GTB Study Visibility and Glare

Suggestion on how to implement the outcome in Regulation No. 48

Draft 07 series of amendments to Regulation No. 48

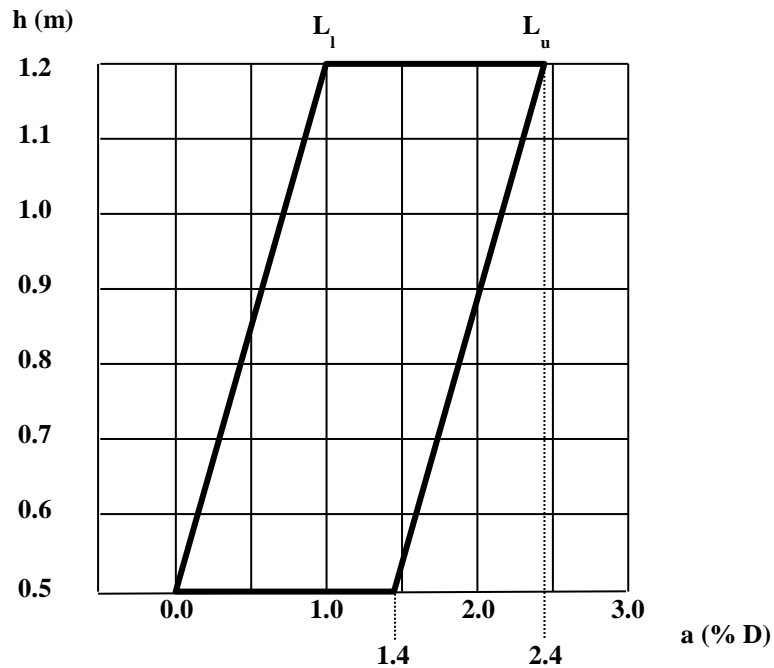
- 6.2.6.1.1.2. **Depending on the mounting height in metres (h) of the lower edge of the apparent surface in the direction of the reference axis of the dipped-beam headlamp, measured on the vehicles under the loading conditions as prescribed in Annex 5 - Part A of this Regulation, the downward inclination of the cut off of the dipped beam headlamp shall remain between the following limits (see diagram below):**

Ll: Lower aiming [and initial downward inclination] limit $Ll = (h-0.5) / 0.7$

Lu: Upper aiming [and initial downward inclination] limit $Lu = (h+0.48) / 0.7$

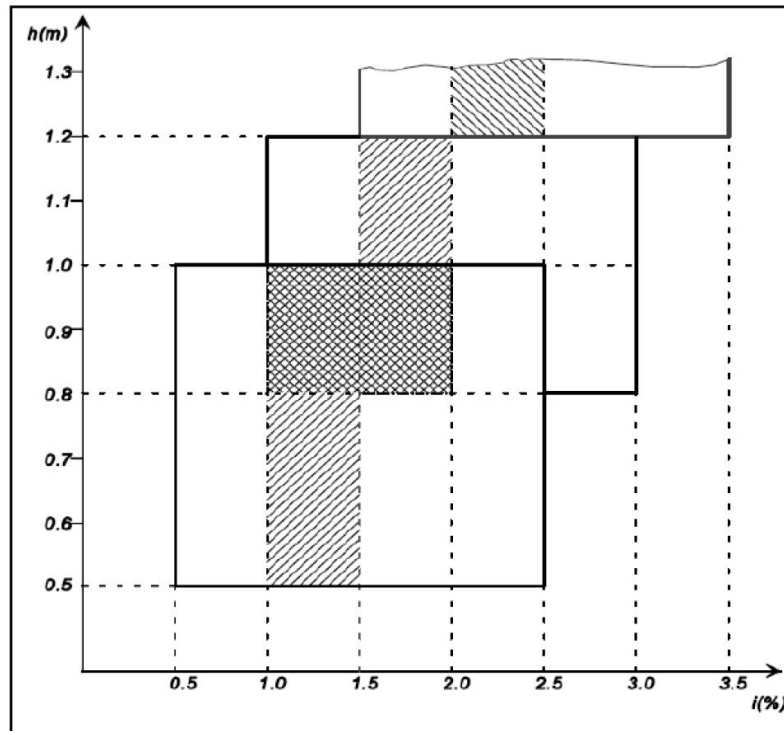
6.2.6.1.2.2. Depending on the mounting height in metres (h) of the lower edge of the apparent surface in the direction of the reference axis of the dipped-beam headlamp, measured on the unladen vehicles, the vertical inclination of the cut-off of the dipped-beam shall, under all the static conditions of Annex 5, remain between the following limits and the initial aiming shall have the following values:

The above limits and the initial aiming values are summarised in the diagram below.

Indication of the downward inclination of the dipped-beam headlamps cut-off referred to in paragraph 6.2.6.1.1. and 6.2.6.1.2.1. and of the downward inclination of the front fog lamp cut-off referred to in paragraph 6.3.6.1.2. of this Regulation

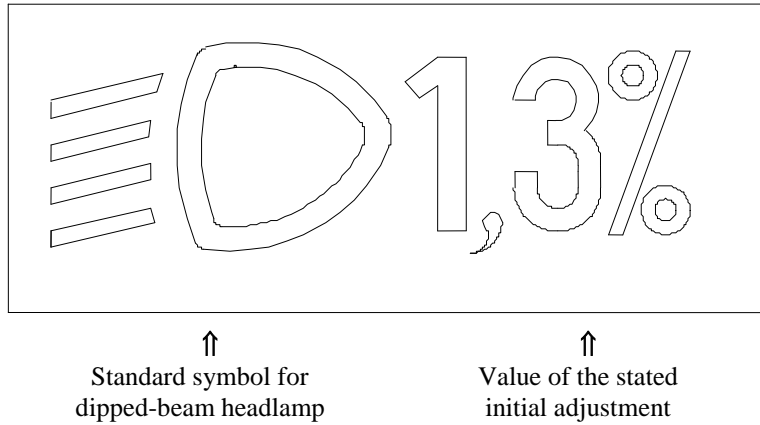
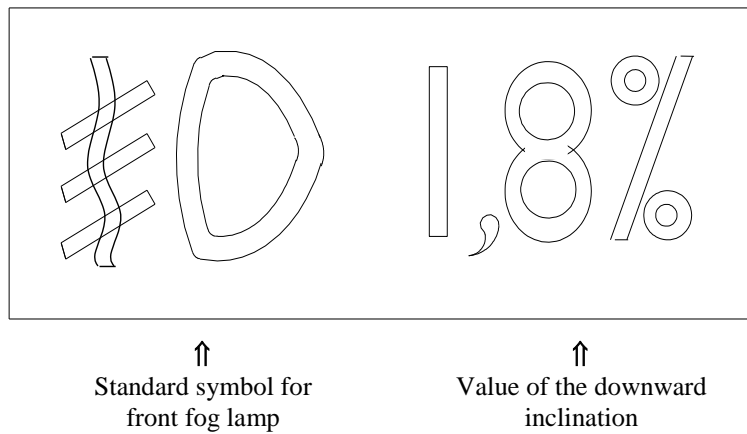
~~The size of the symbol and characters is left to the discretion of the manufacturer.~~

~~The size of the symbol and characters is left to the discretion of the manufacturer.~~

Note: The size of the symbol and characters is left to the discretion of the manufacturer.

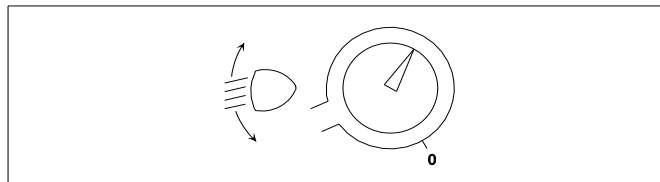
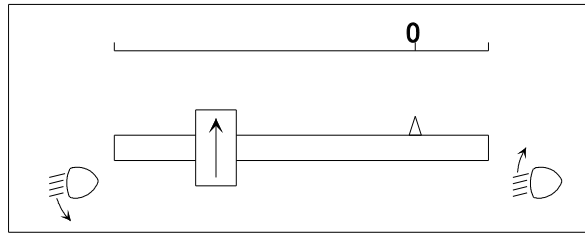
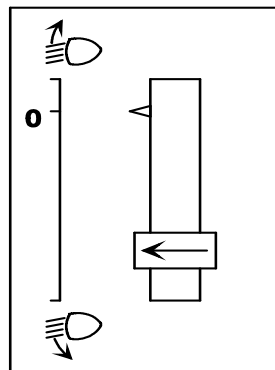
~~Symbols employing five lines instead of four may also be used~~

Note: Symbols employing five lines instead of four may also be used

The Polish proposal; see GRE-71-32, page 162

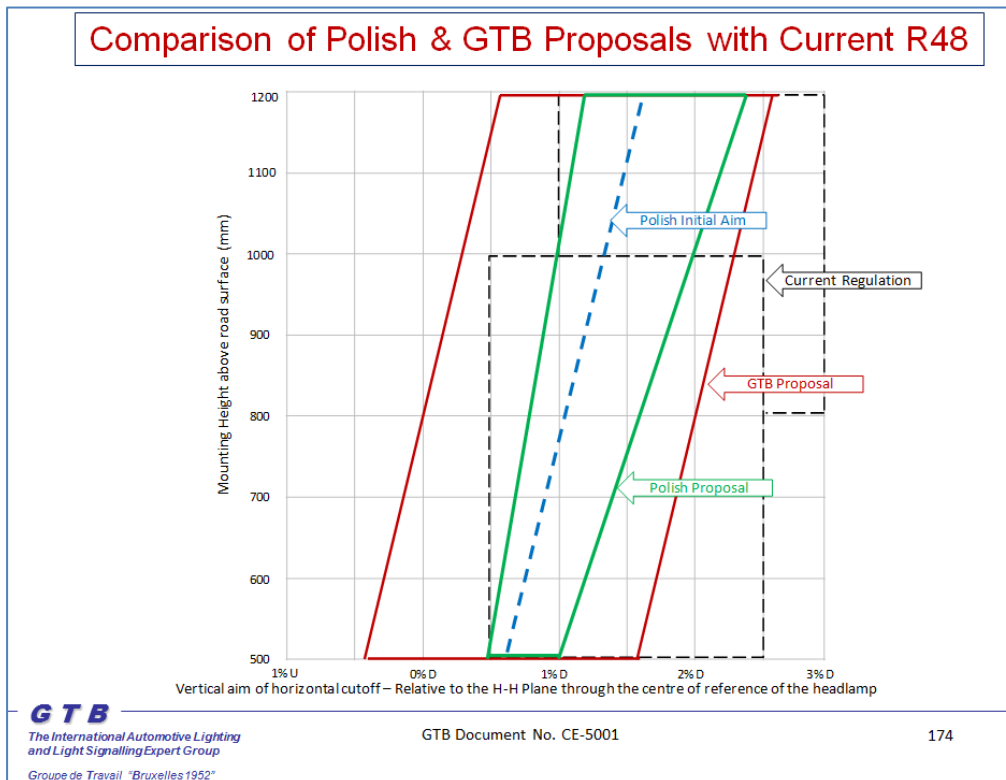
The aiming limits as proposed by the expert from Poland focus on maintaining adequate road visibility distance. They are based upon the translation of the photometric requirements at the test points of the headlamp regulations into an estimate of values produced at points on the road surface and are “Worst Case”, taking account of the lowest performing headlamps that meet the type approval requirements. Avoidance of glare is not directly addressed. It assumes that the horizontal cut-off should not extend beyond 100m distance from the vehicle.

Merging the Polish and GTB proposals:

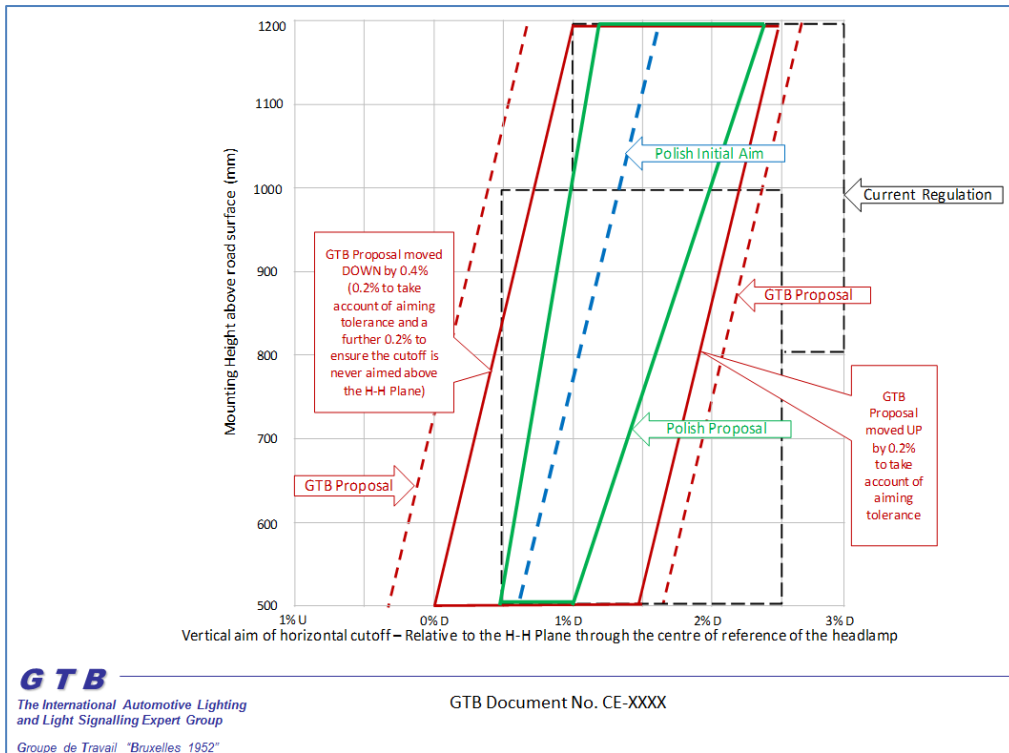
- a. Considering the information from the expert from OICA (see GRE-67-27 and GRE-68-20), the final proposed aiming limits should be less narrow than the “worst case” limits proposed by the expert from Poland. So the green aiming limits in the drawing above should be shifted outwards.

- b. On the other hand, the “current practice” limits proposed by GTB should be narrower to reflect progress of technology. So the red aiming limits in the drawing above should be shifted inwards.

- c. Real world tolerances should be proposed. A shift of the GTB proposed aiming limits to take a 0.2% tolerance into account therefore can be considered to be a logical first step.

- d. Despite the GTB explanation in GRE-71-32 pages 171 and 172 that aiming above HH should not create more glare problems; knowing that for some governments the priority is to avoid risk of glare; knowing that for other governments visibility distance at the cost of acceptable glare is important; it was concluded that aiming limits should stay below HH but should not be shifted more than that. This means another shift of 0.2% of the GTB proposed left limit. This additional shift can also be justified by the fact that the left aiming limit is mainly related to avoid glare and the right aiming limit is mainly related to provide sufficient road visibility distance. Glare and visibility distance are different mechanisms.

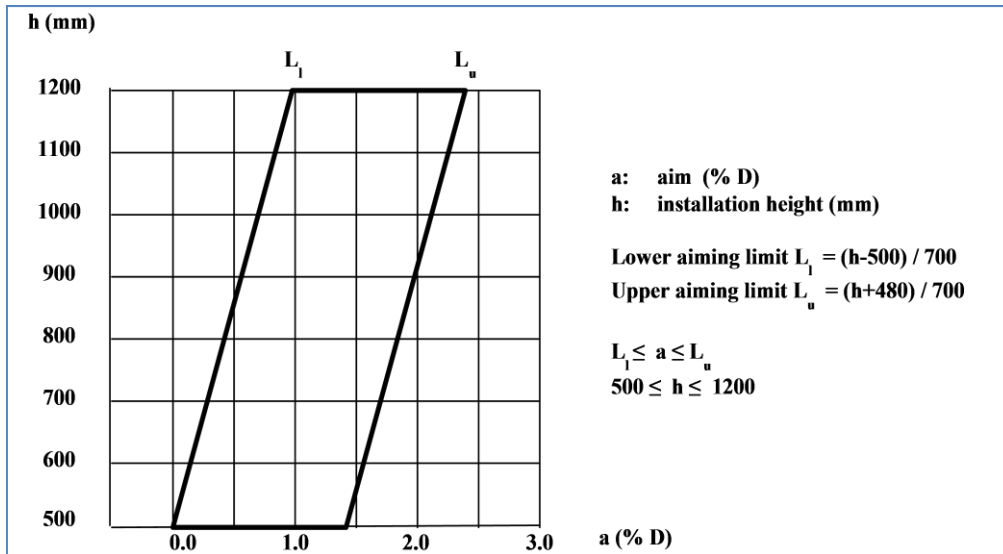
- e. The result of shifting the GTB aiming limits is given below.

- f. Since the aiming tolerance is only 1.5%, it was concluded that initial aiming should not be prescribed but should be specified by the manufacturer within these limits.
- g. Since a drawing is less accurate, a mathematical description of the aiming limits is inserted next to the drawing.
- h. The expert from Poland expressed that he may wish to reconsider the upper aiming limit on the right.
- i. The expert from OICA requested more time to confirm whether the proposed aiming tolerances are achievable in daily practice.
